## **PLANNING**

Items in red indicate proposed changes to planning approval **19/1228/HOT** (20 November 2019)

Proposed Front Elevation
Scale: 1:100

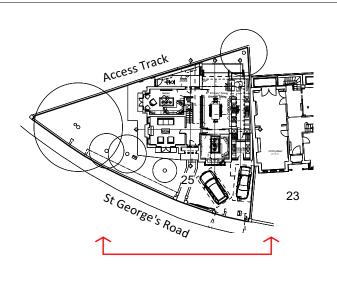
New timber framed, double glazed windows to replace existing

Footprint of existing side
Garage reduced to sit behind
principal front elevation.

Amendments to approved

Roof ridgleine raised by 0.75m to accommodate new 4th bedroom

Window cills to dropped to create

French doors.

and ensuite bathroom.

conservation roofights

Grey line indicates Roofline

approved under 19/1228/HOT
